REBUTTAL PROOF OF EVIDENCE OF CLIVE SELF

LANDSCAPE AND VISUAL MATTERS

APPLICATION REFERENCE: IP/24/00172/OUTFL

Land at Humber Doucy Lane, Ipswich, Suffolk

Figure 3 Indicative walking route to LEAP

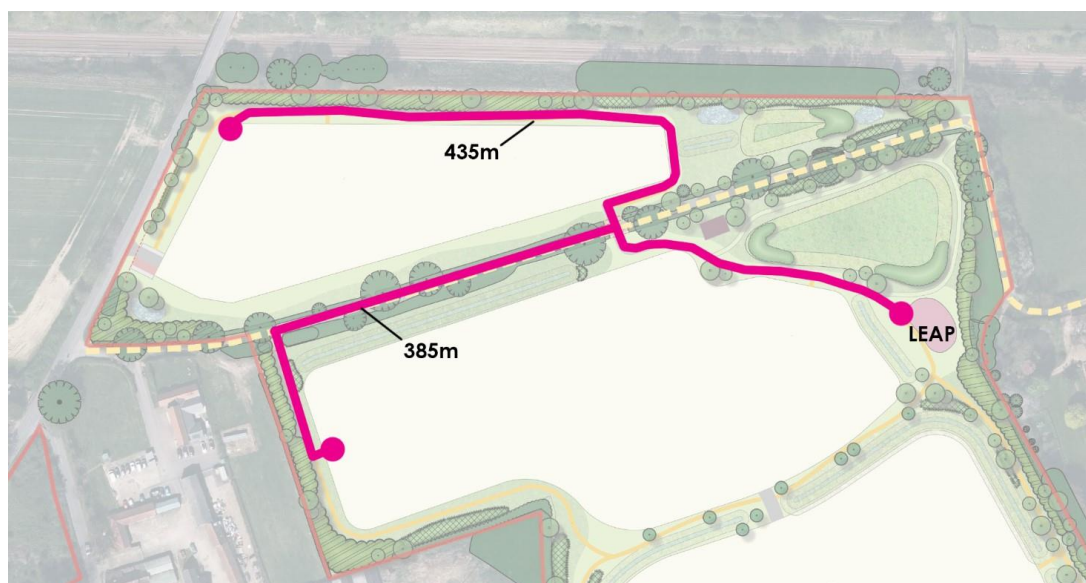
22. At paragraph 7.26 Ms Chittock refers to page 119 of the DAS and provides an annotation of Figure 5 where she highlights, in red, two areas which she says are outside of the 5 minute walking radius for LEAPs.

23. Unfortunately, this is a misinterpretation of Figure 5. The 240 m linear isochrone on Figure 5 is derived from the Fields in Trust Guidance of 2008, which I was one of the authors of. In the 2008 document, the walking distance to a LEAP is 400 metres with the 'Straight Line Distance' as 240 metres. The reason for providing a shorter 'Straight Line Distance' was to give an indication of what a typical walking distance to play area would be within a development, as at the outline planning stage, there would be no definitive plan to enable the exact distance to be calculated. The latest iteration of the Fields in Trust Guidance no longer contains 'Straight Line Distances'.

25. Figure 3 is an extract from the Illustrative Landscape Strategy which has been annotated to show the most distant properties from the LEAP in the northern part of the site. This shows that at the most northern tip of the site the maximum walking distance to the LEAP would be approximately 435 metres. Although, in reality, the distance is likely to be shorter as there would be an internal road serving the properties but given that the layout is not fixed at this stage one cannot measure the actual distance.

26. At the outline planning stage it is not possible to provide a definitive walking distance from each property to each play area but on any reasonable basis the vast majority of properties within the Appeal Site would be within the required walking distances, or in the worst case, only marginally over. If this remained a concern of the Local Authorities then the play areas could be moved to address this concern.
